UNITED STATES PATENT AND TRADEMARK OFFICE

APPLICATION NO.	FILING DATE	FIRST NAMED INVENTOR	ATTORNEY DOCKET NO.	CONFIRMATION NO.
10/075,149	02/14/2002	Milivoje Aleksic	00100.02:0060(990060D-1)	7928

Office Action Summary

Izchetta discloses a data processing system as shown below in Fig. 4:

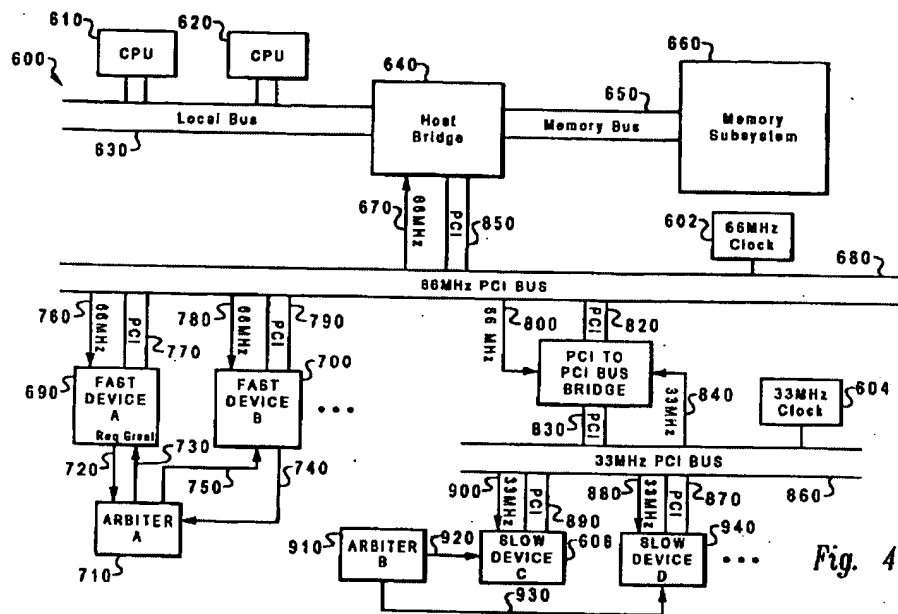
a system controller or host bridge 640 connected to memory 660 via a memory bus 650, a high speed arbiter 710 for providing arbitration to high speed devices A and B, an I/O controller or PCI/PCI bus bridge 810 coupled to a high speed bus 680, a low speed arbiter 910 for providing arbitration to low speed devices C and D; the PCI/PCI bridge 810, the fast devices A and B are all connected to high speed bus 680.

Izchetta does not disclose that the high speed arbiter may be included in the system controller or host bridge 640; and the low speed arbiter may be included in the I/O controller or PCI/PCI bridge 810.

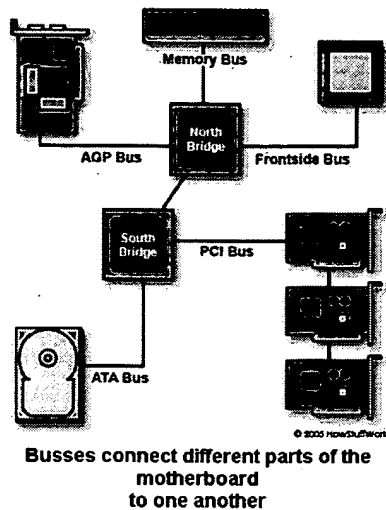
The further difference between the claim subject matter and lachetta is the use of dual channel memory controller. However, the use of dual channel memory controller, first developed by Intel, is old and well-known, as evidenced by at least Heil. Heil discloses a multiple-port structure. Heil discloses two separate memory channel controllers (figure 8, structures 134, 136, 142, and 144). Heil teaches that the general access latency caused by the severe bandwidth constraint can be improved with the dual memory channels (column 1, lines 52-56). Thus, it would have been obvious to one having ordinary skill in the computer art at the time Applicant made the invention to adapt Heil's teachings into lachetta for the purpose of improving the general access latency by the dual memory channels. Note also that it is inherent that a computer system, such as the system disclosed by lachetta must include a hard drive, and the hard drive is connected to the PCI bridge or PCI south bridge. See diagram below from How Motherboards Work, cited below. Note also that ATA Bus is operated as a higher speed than the low PCI Bus (33 Mhz).
